**Basis Statement
State Implementation Plan for Regional Haze**

Commenters

Visibility Improvement Relative to Uniform Rate of Progress at Acadia National Park

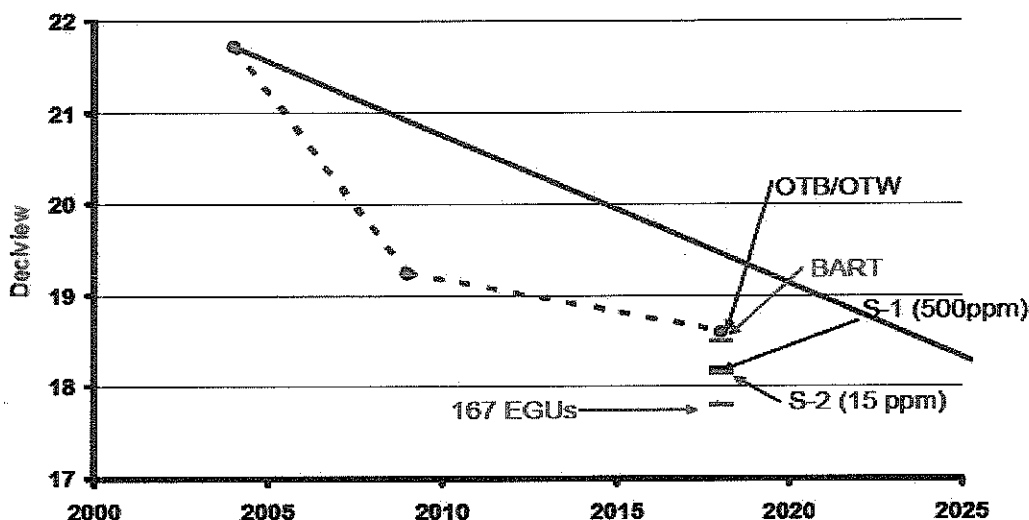
41) By setting reasonable progress goals based on the "Ask", rather than the OTW/OTB inventory, the MANE-VU States have made it more difficult to demonstrate that they have implemented the controls necessary to meet the reasonable progress goals. It would

be helpful for Maine to discuss whether or not the OTW/OTB controls were sufficient to meet the uniform rate of progress at the Maine Class I areas. (2)(3)

The following graphics (from the NESCAUM Report "MANE-VU Modeling for Reasonable Progress Goals") illustrate that the emission reductions modeled under the OTB/OTW scenario, are sufficient to meet uniform rate of progress at Maine Class I areas:
